# DART SERVICE INSTRUCTION

TO AMEND INSTALLATION DRAWING D2046901 REV. 6

A	NEW ISSUE	XDF	11.10.26
REV.	DESCRIPTION	BY	DATE
DESIGN	XDF	<b>DART AEROSPACE LTD</b> HAWKESBURY, ONTARIO, CANADA	
DRAWN	XDF		
CHECKED		DRAWING NO.	REV. A
MFG. APPR.	N/A	DSI 9581	SHEET 1 OF 1
APPROVED		TITLE	SCALE
DE APPR.		SCREW REPLACEMENT	NTS
DATE	11.10.26	COPYRIGHT © 2011 BY DART AEROSPACE LTD THIS DOCUMENT IS PRIVATE AND CONFIDENTIAL AND IS SUPPLIED ON THE EXPRESS CONDITION THAT IT IS NOT TO BE USED FOR ANY PURPOSE OR COPIED OR COMMUNICATED TO ANY OTHER PERSON WITHOUT WRITTEN PERMISSION FROM DART AEROSPACE LTD.

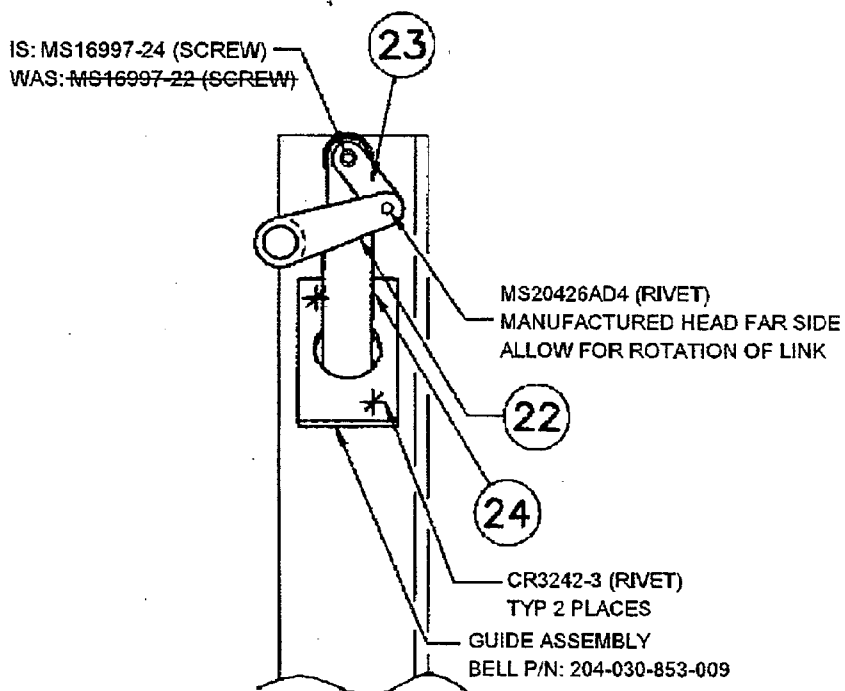
The purpose of this service instruction is to replace the MS16997-22 screw used in the latch assembly with MS16997-24 screw.
